RE: THE TOWERS SUBDIVISION UNIT 1

Engineers Certification for Release of Financial Guaranty

DRAINAGE REPORT FOR THE TOWERS SUBDIVISION

TYPE B. INLET SAG 5124.0 一名人口 (11/EPT 59)。 HP

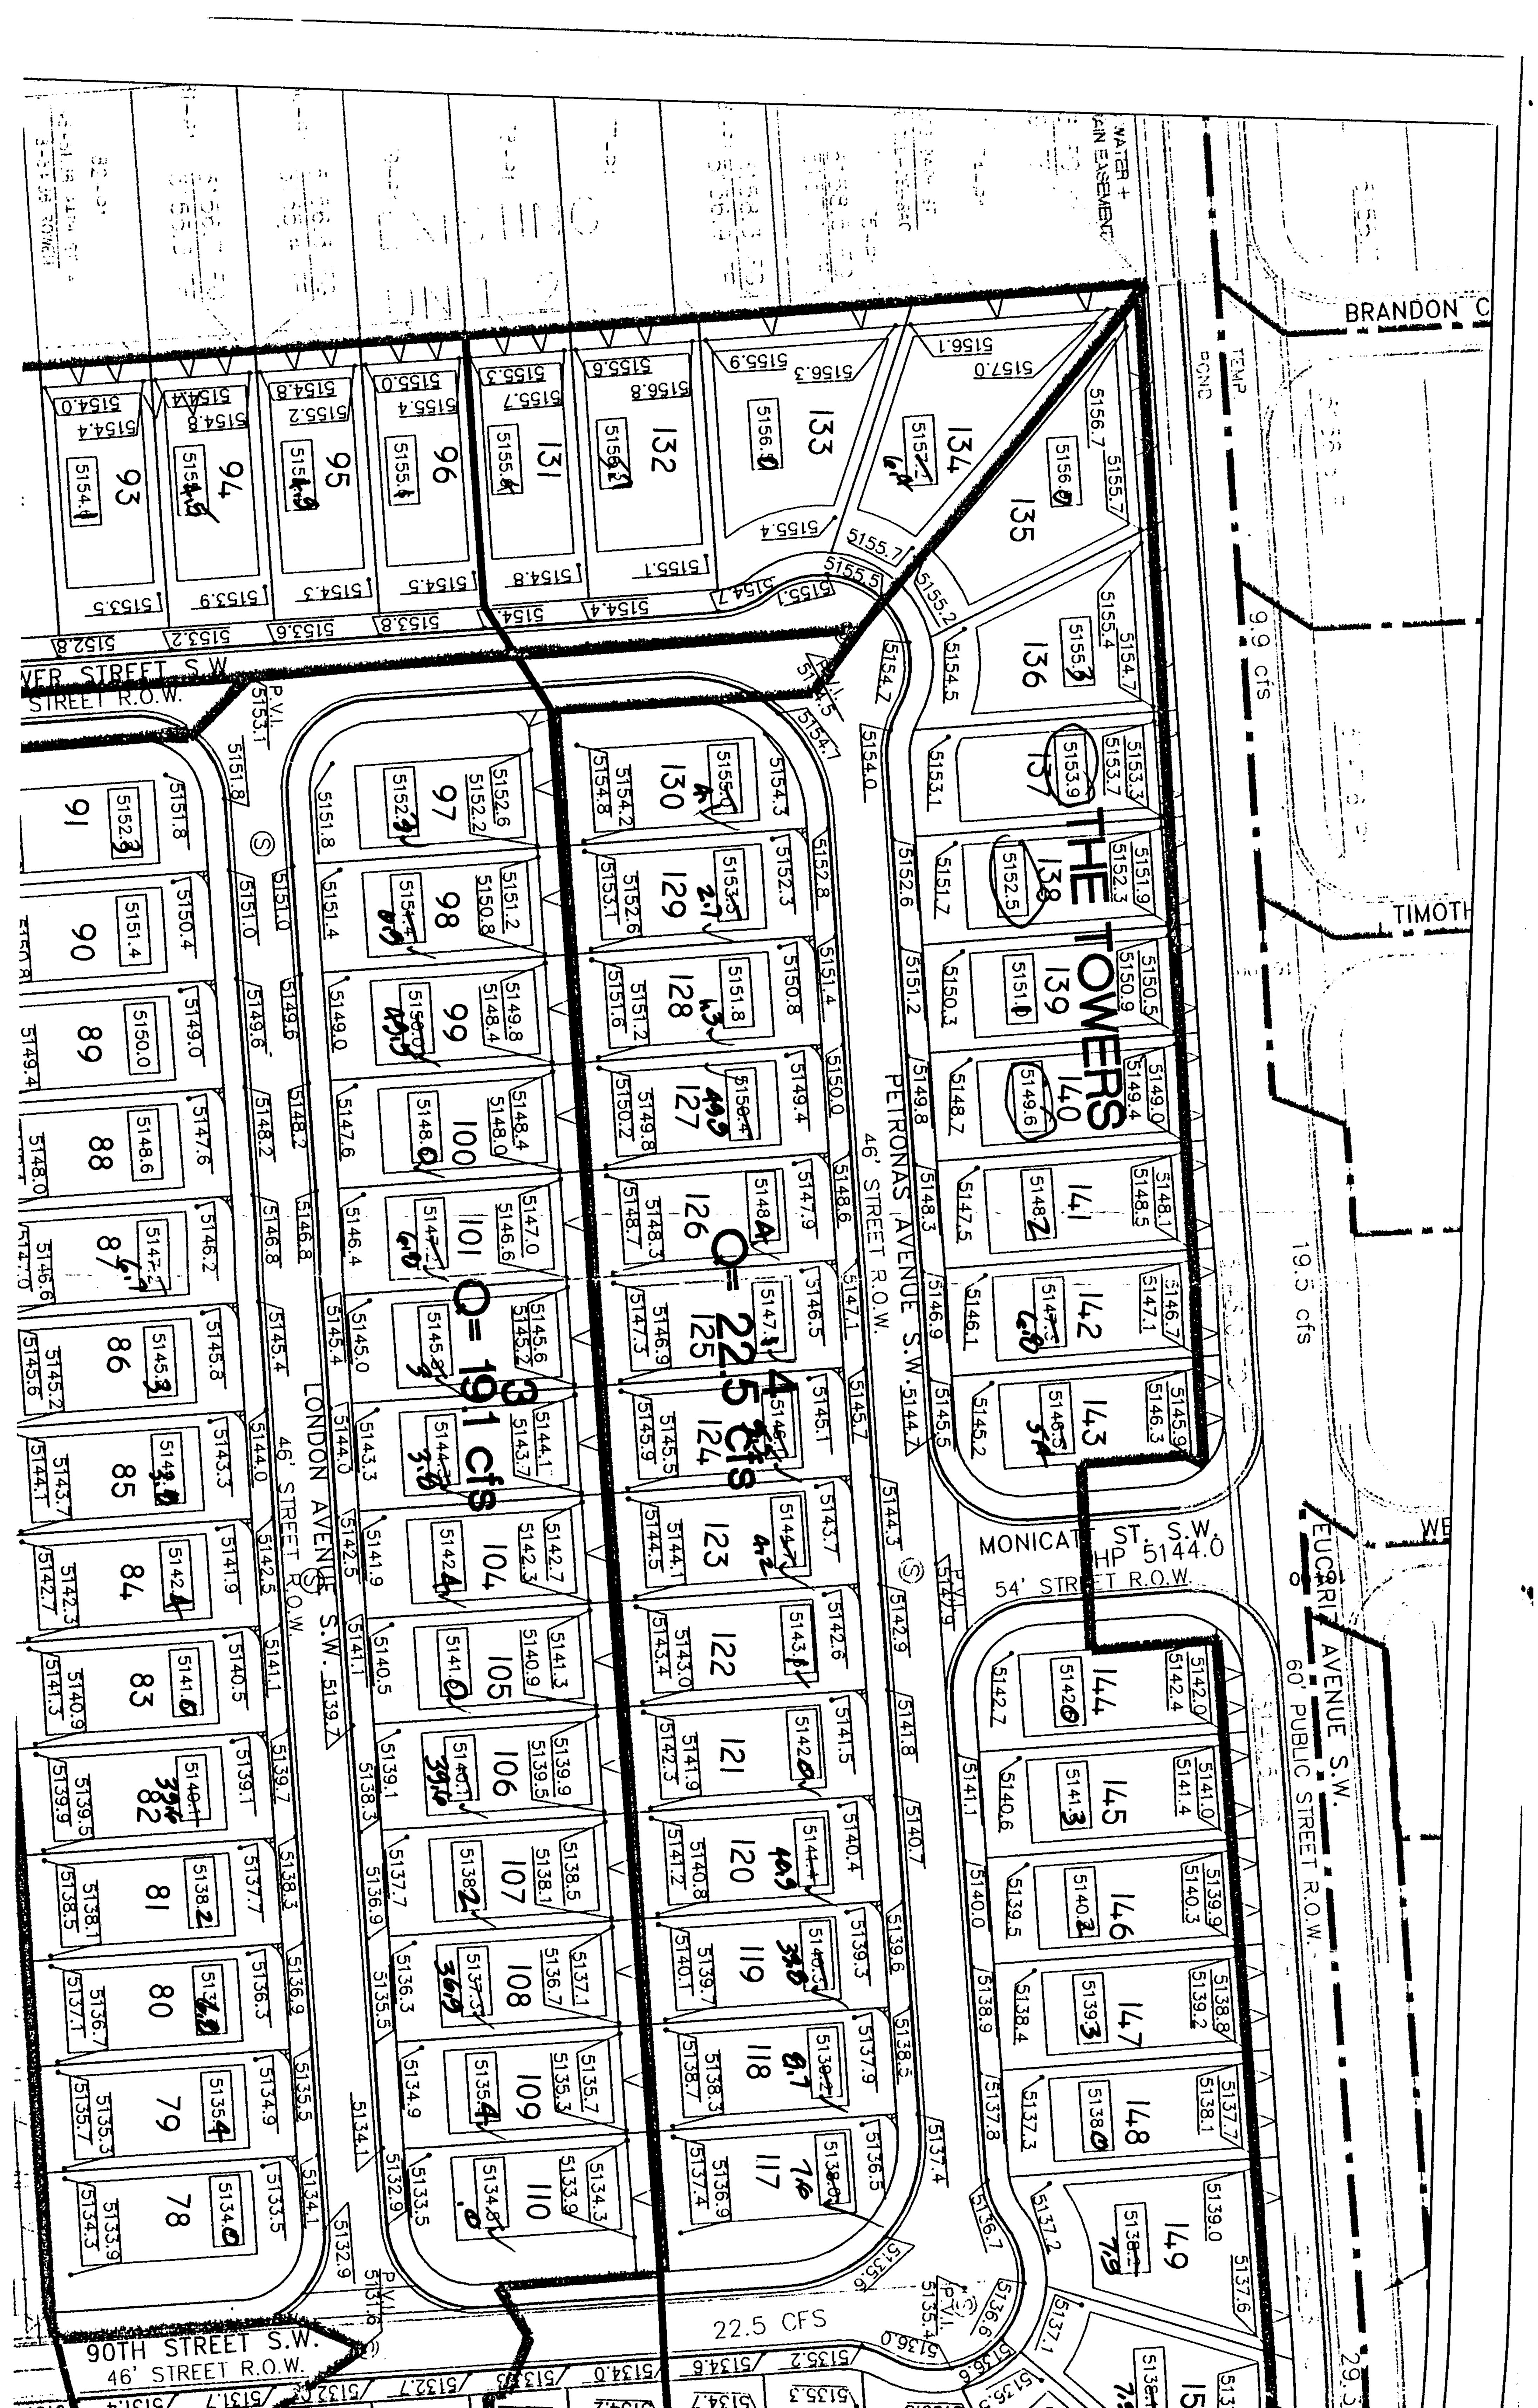
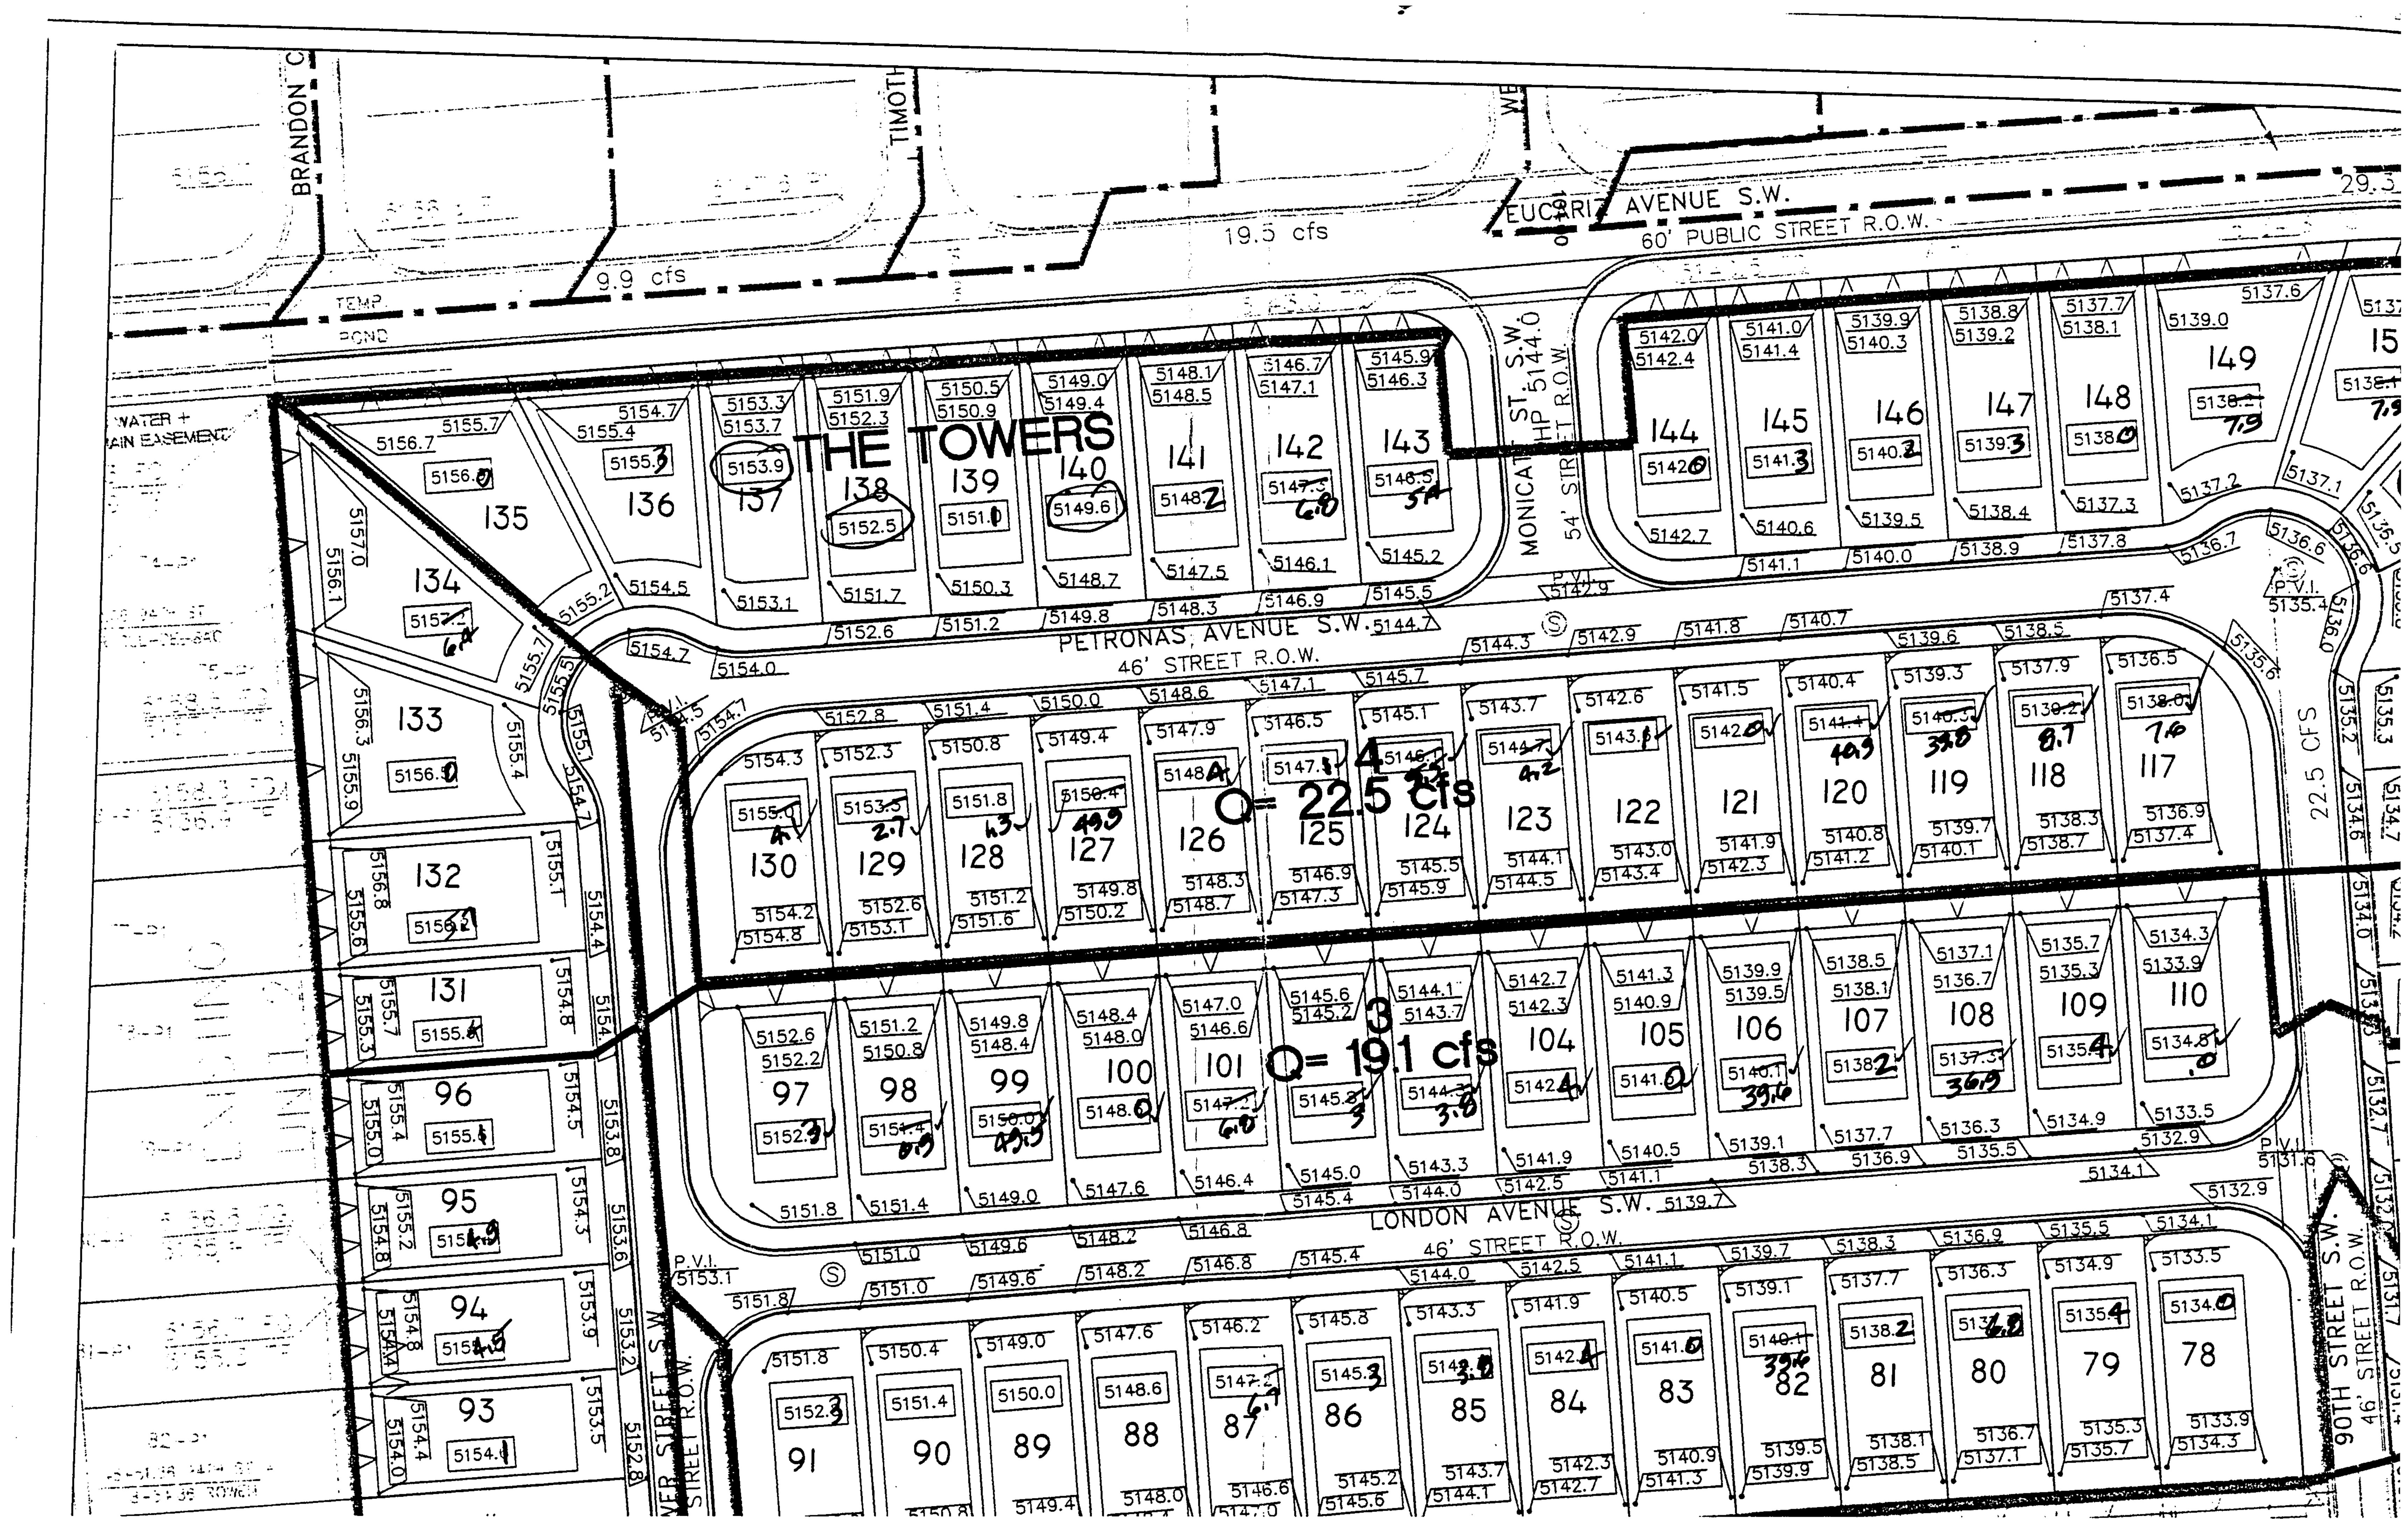
- On the Engineers Certification by Resource Technology, with the elimination of the retaining wall on Tower Road, asbuilt elevations need to be provided, as well as a more detailed exhibit showing the change in the grading pattern in the rear yards regarding the drainage flow pattern for lots 1-18 on Tower Ave.
- An SO19 permit was needed pertaining to the inlet in the drivepad at Eiffel Ave and 90th St; the contractor needs to obtain the permit, and have the City's Storm Drainage Maintenance Inspector approve the SO19 improvement.
- Since a different engineer was chosen to provide a grading and drainage plan for the SO19, this plan will also need to be certified by the Engineer.

RE: Grading and Drainage Report for Tower Subdivision Inlet Replacement (L9-D27A)

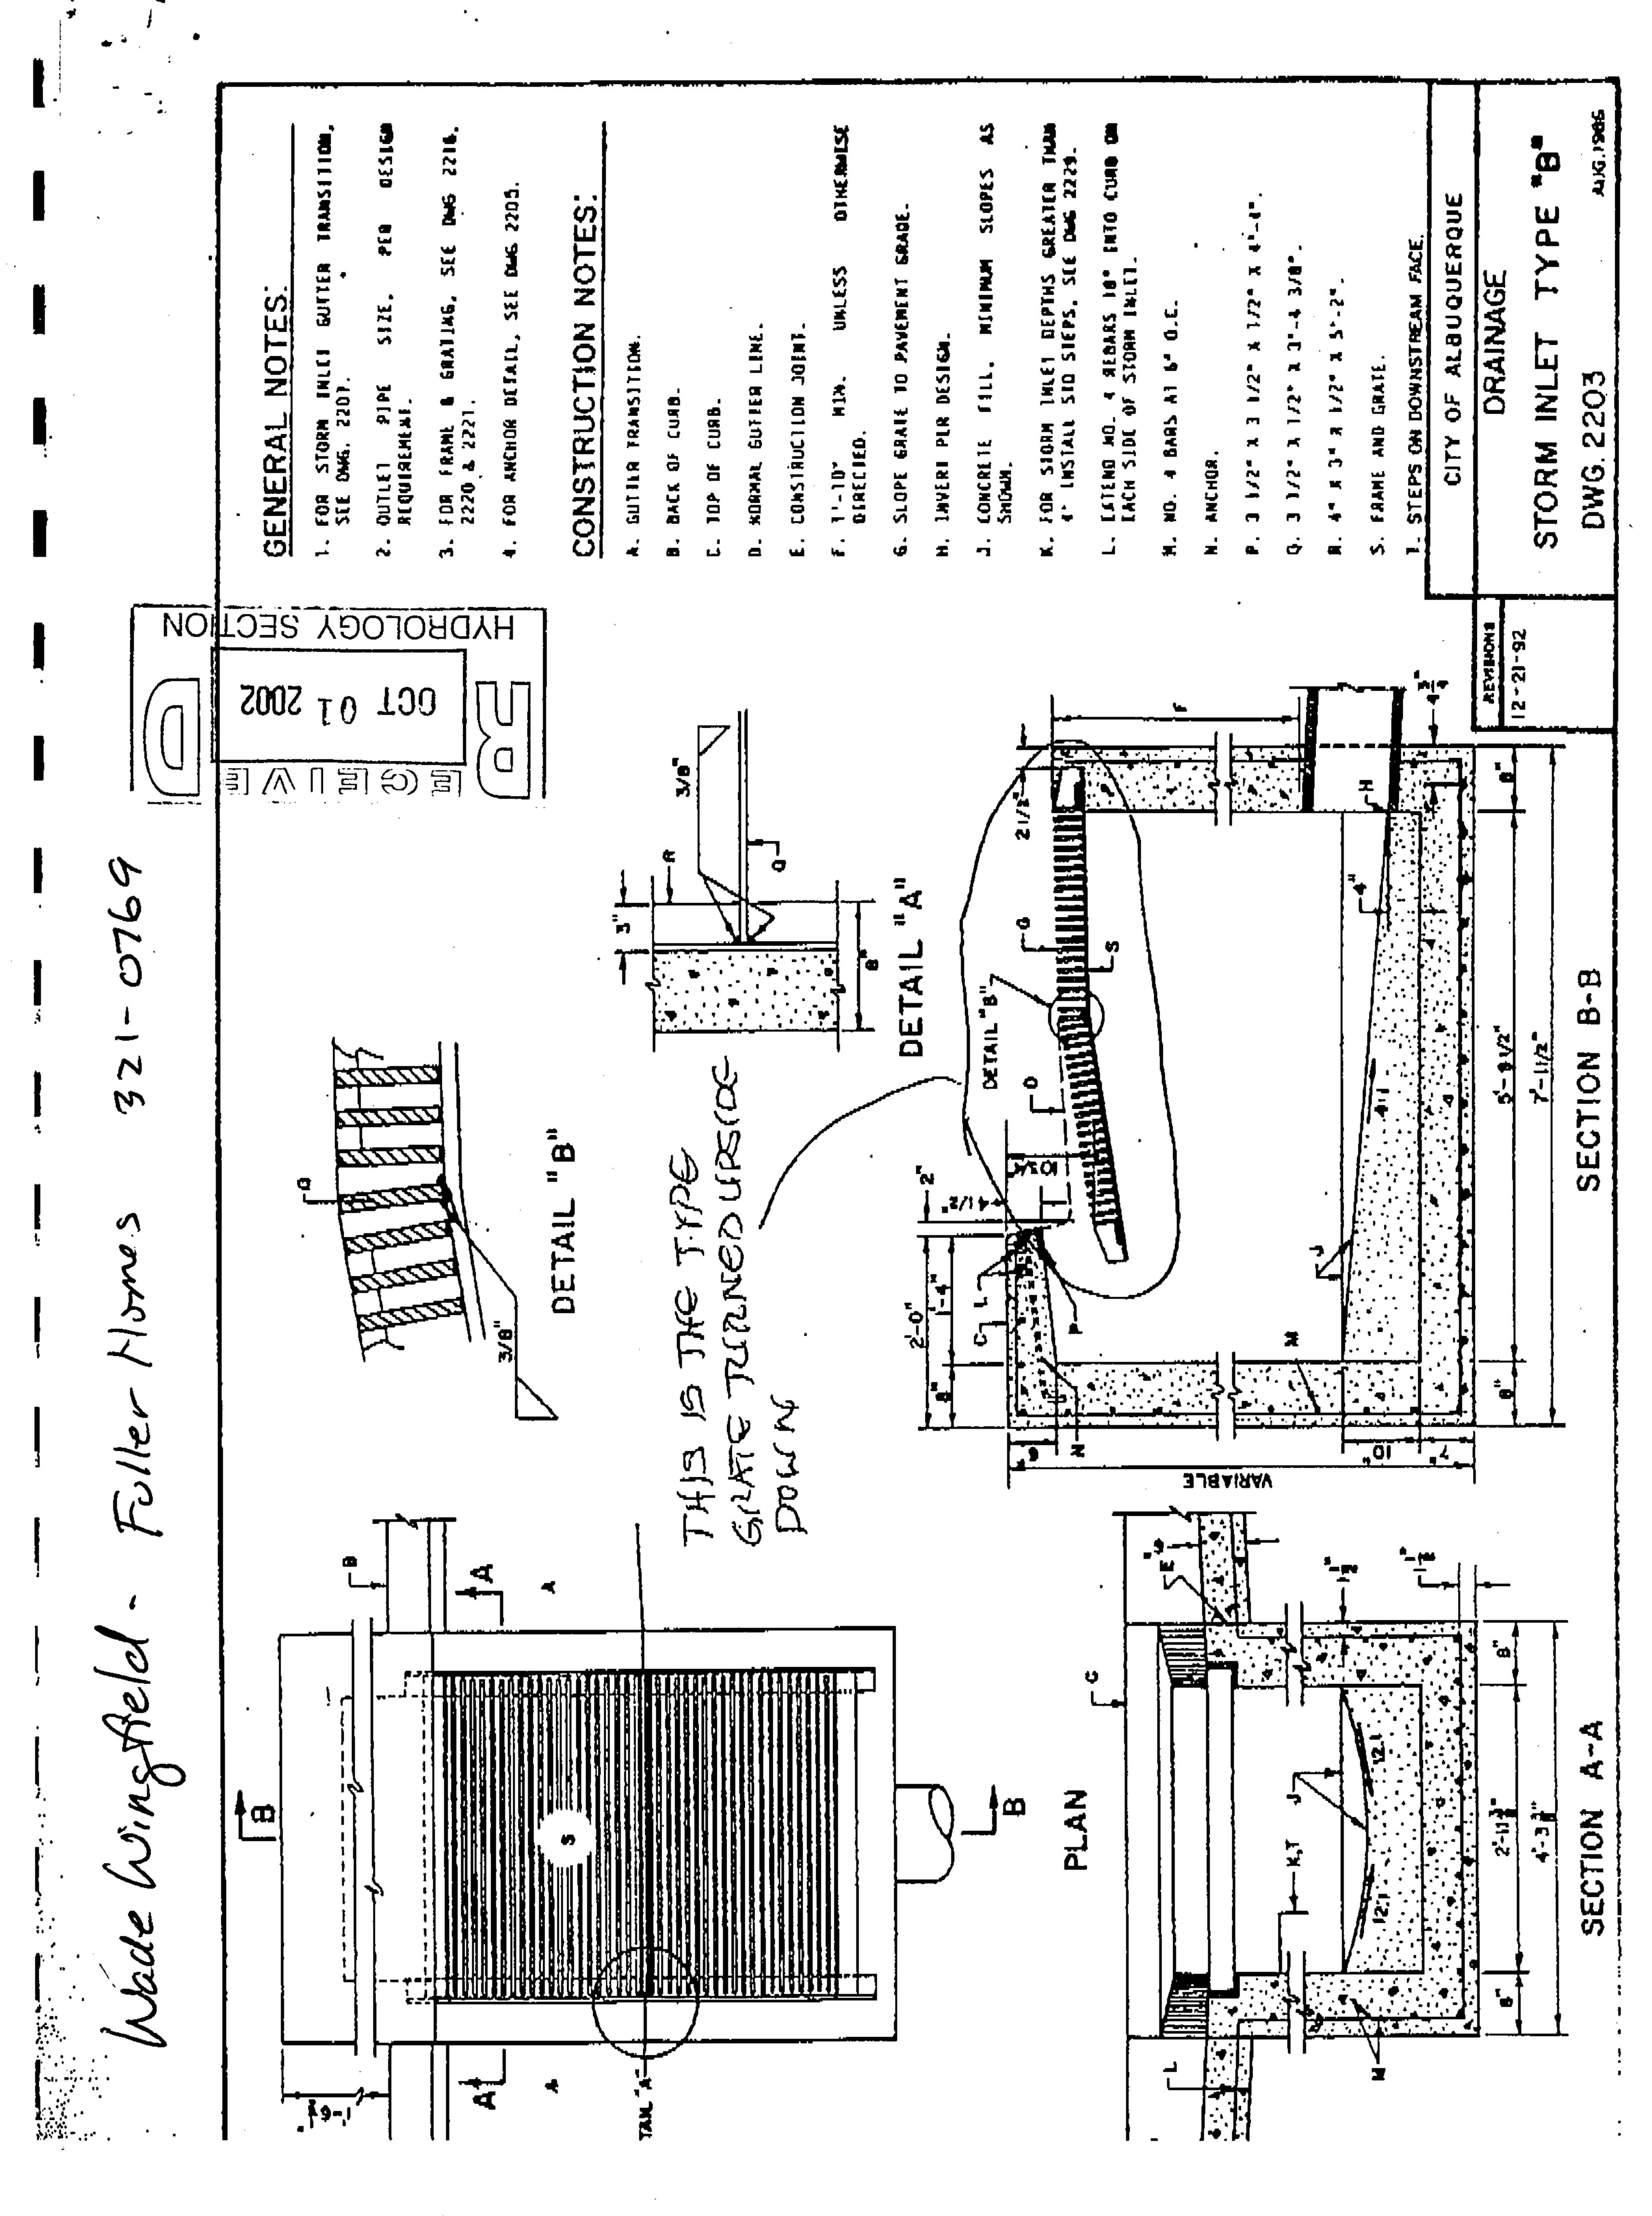
We have different submittals by different individuals for this project. We have a submittal on our list, which was received September 26, 2002, which had not been reviewed by the City. Obviously we have moved on from this submittal. I do want to comment on a field visit that I made to the site.

The lateral connecting the "A" inlet and the modified "D" inlet is at a different elevation than was shown in the drawing and the material of the pipe is different. These changes were made in the field, but they should be as built.
